CITY OF ALBUQUERQUE

PLANNING DEPARTMENT – Development Review Services

RE: Alameda Self Storage (C18D064A)
Grading and Drainage Plan
Supplemental Information, Engineer's Stamp Date 12-15-2014

GRADING AND DRAINAGE PLAN

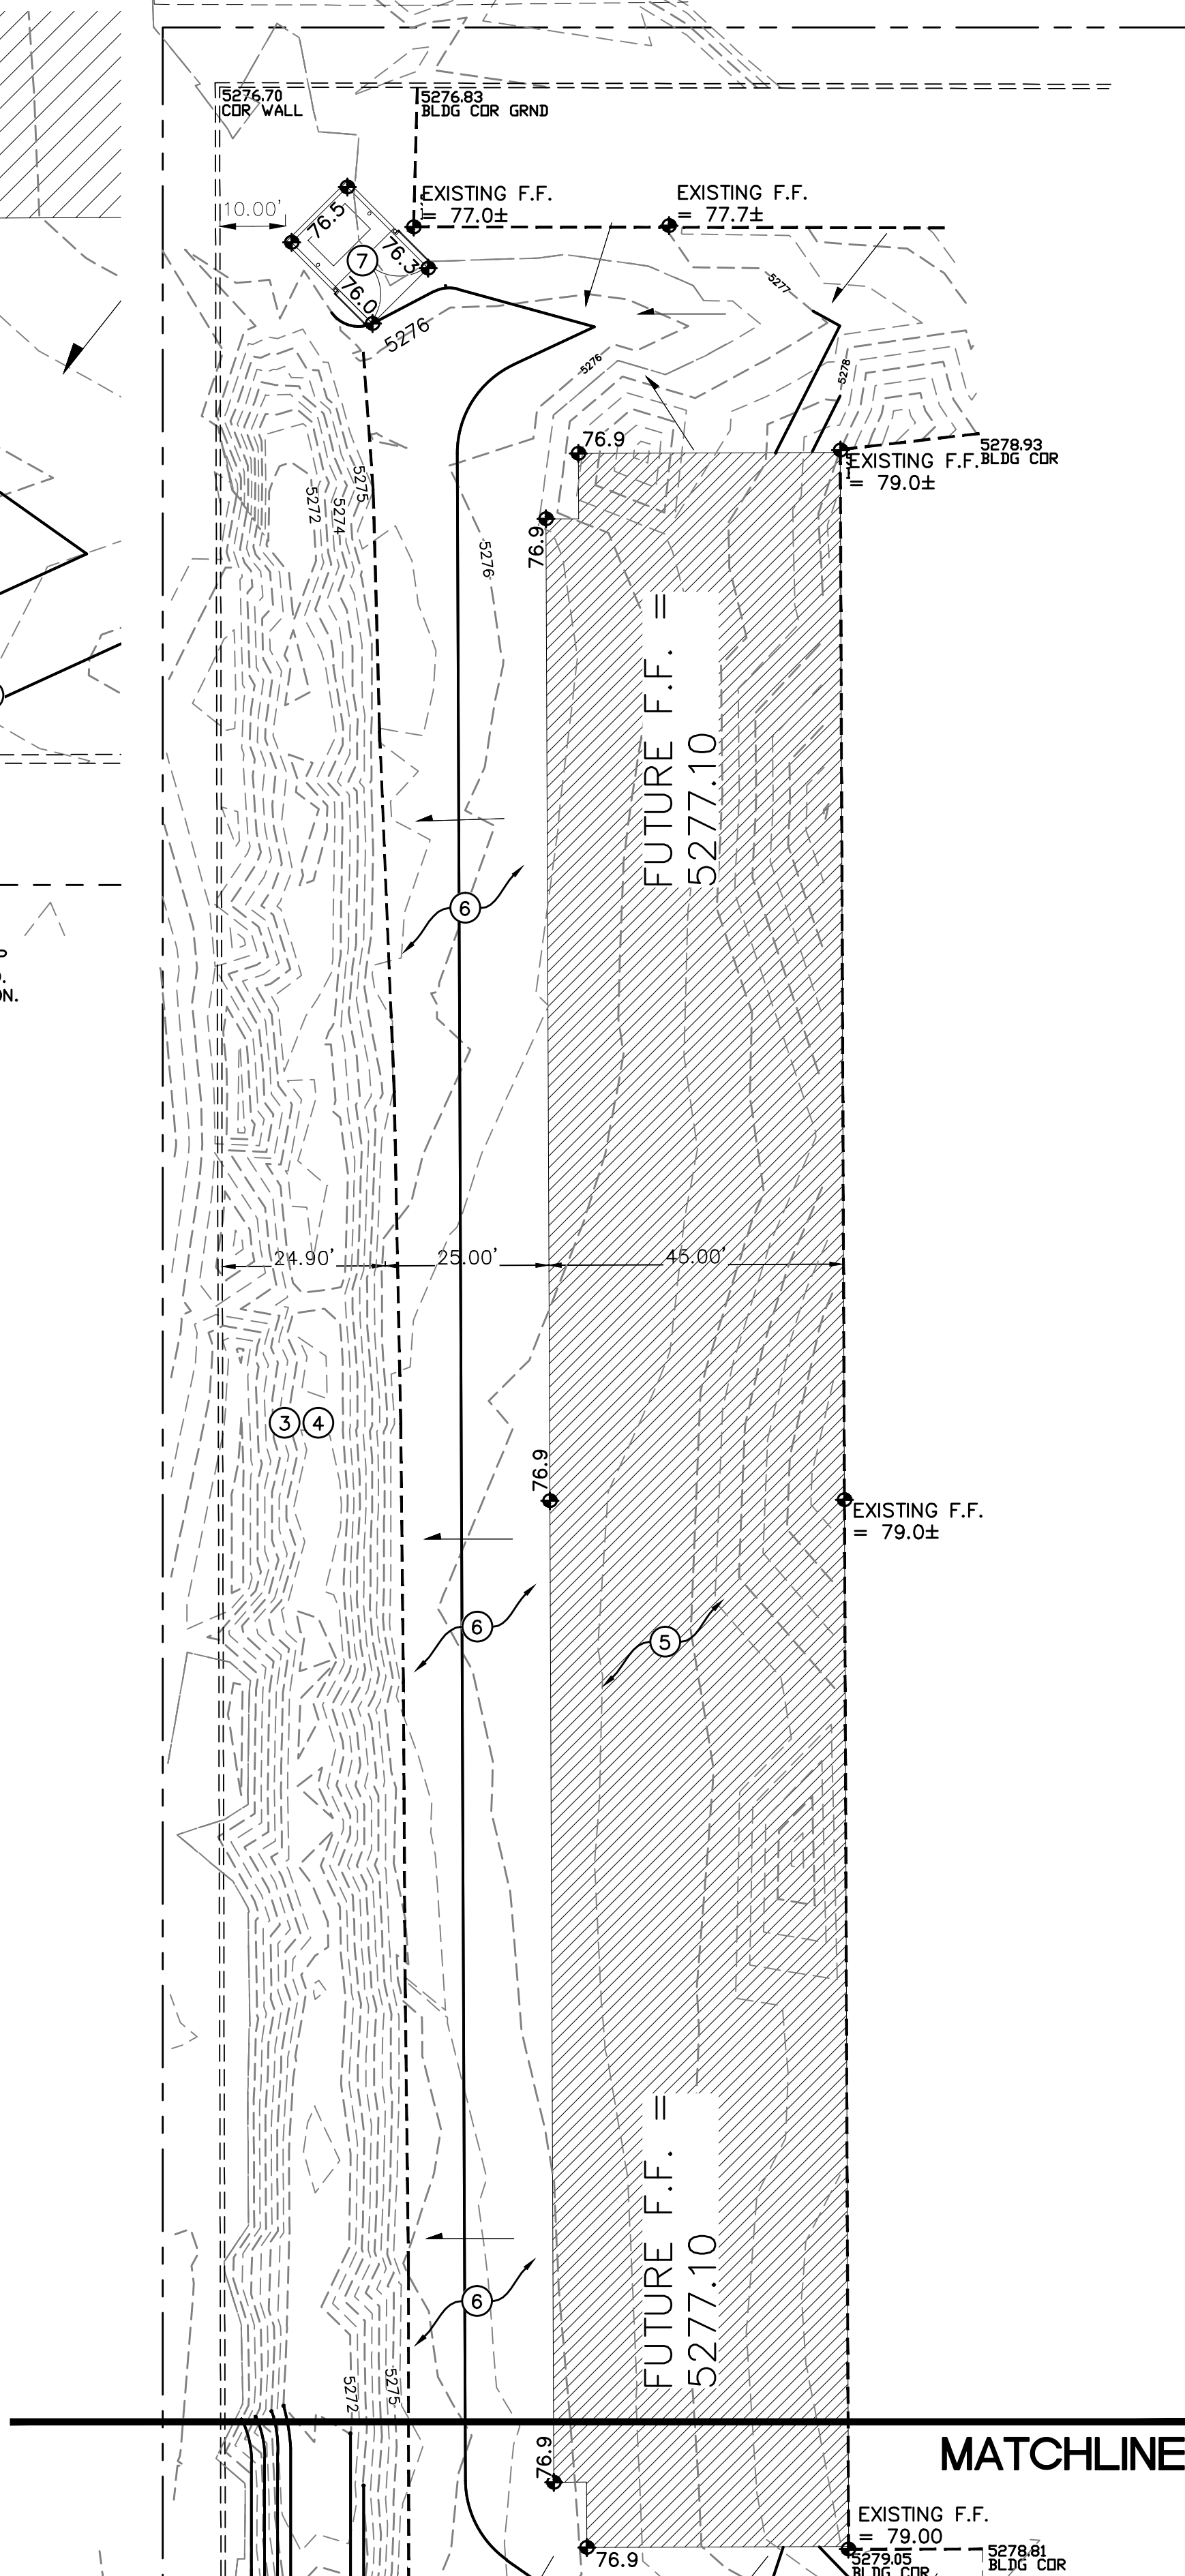
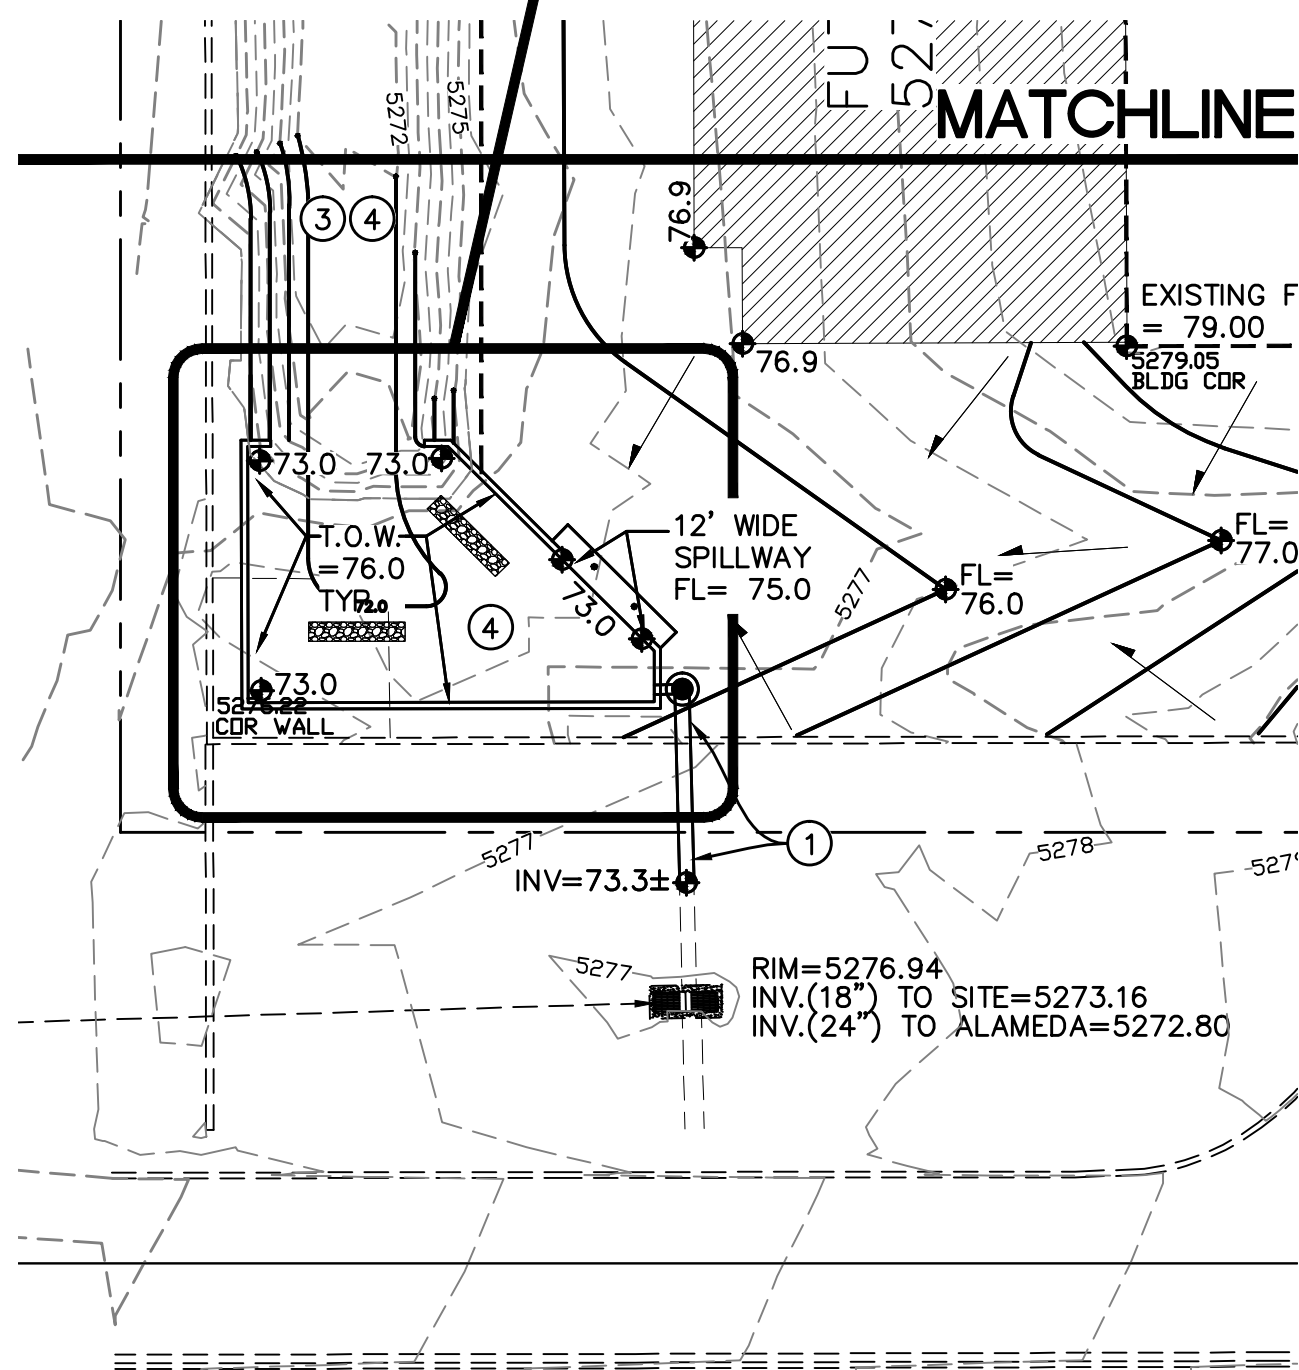
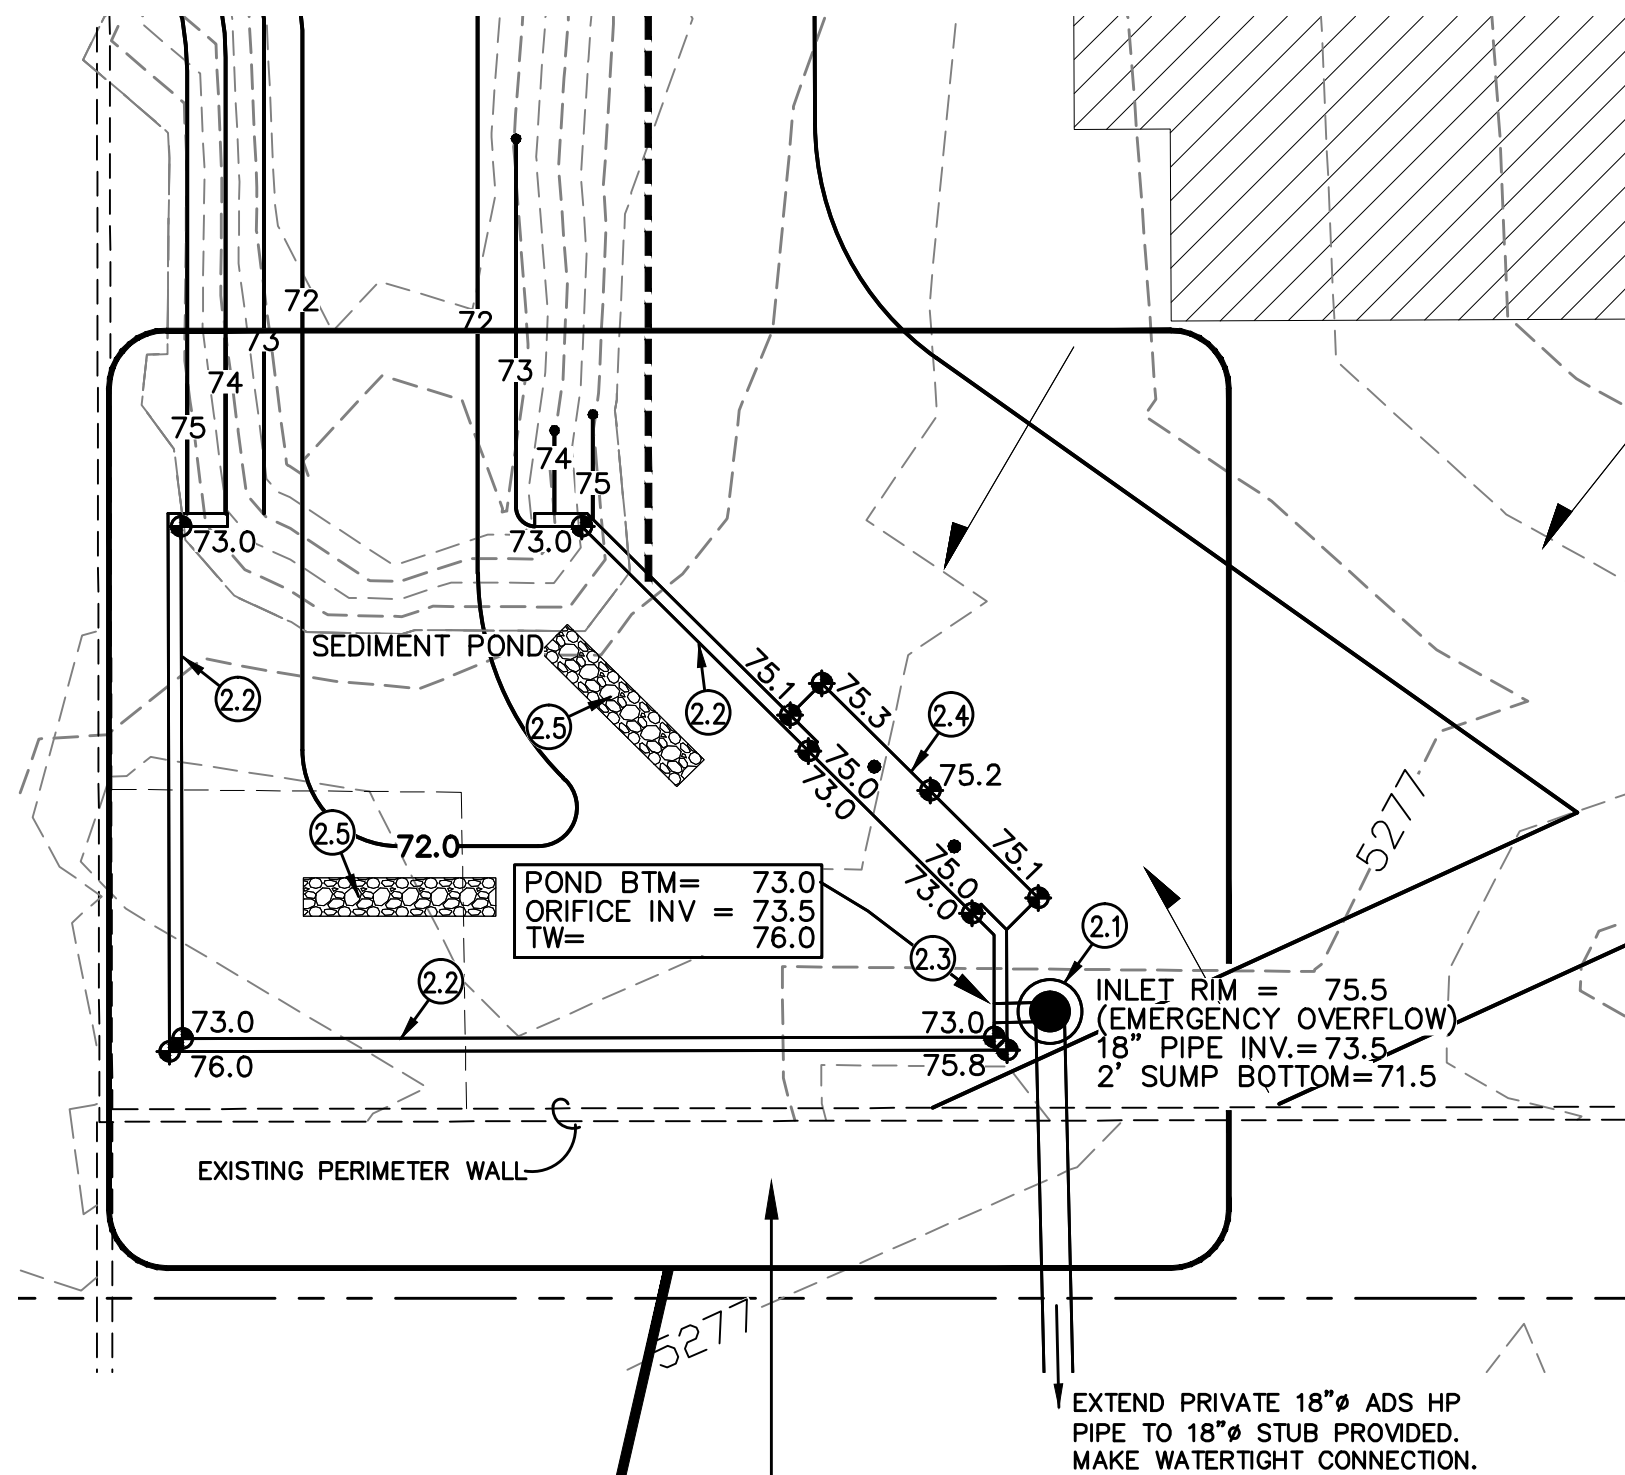
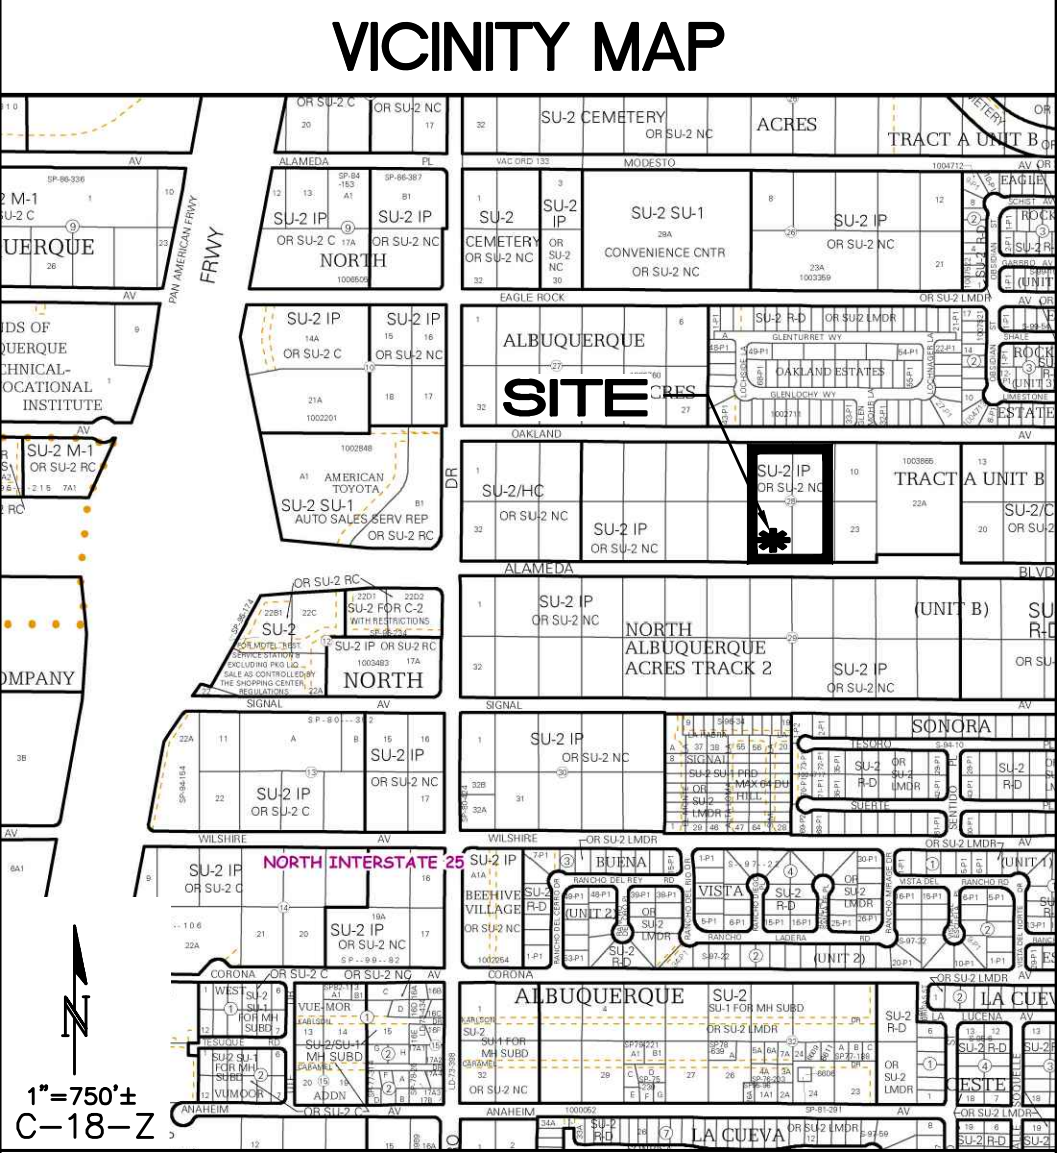
2. Show the contour elevation between the proposed building and the existing pond.
3. Show the scale used.
4. State how the first flush is to be handled. There is a calculation for it on page 2 of the report, but it needs to be adjusted for 3.3 Acres and verbiage needs to be added to state how it is being retained. How much volume is being retained below the bottom of the orifice opening? Is it enough to retain the first flush?

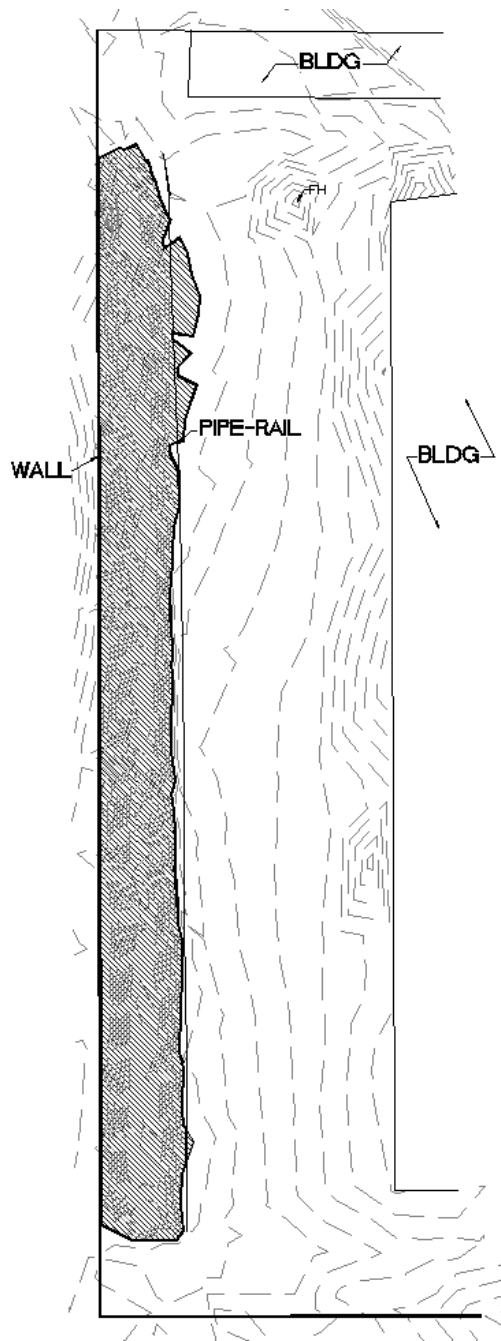
10. Analysis on page 2 shows area as 2.9 Acres, but the 2005 report indicates 3.3 Acres. Using 3.3 Acres will increase the volume detained.
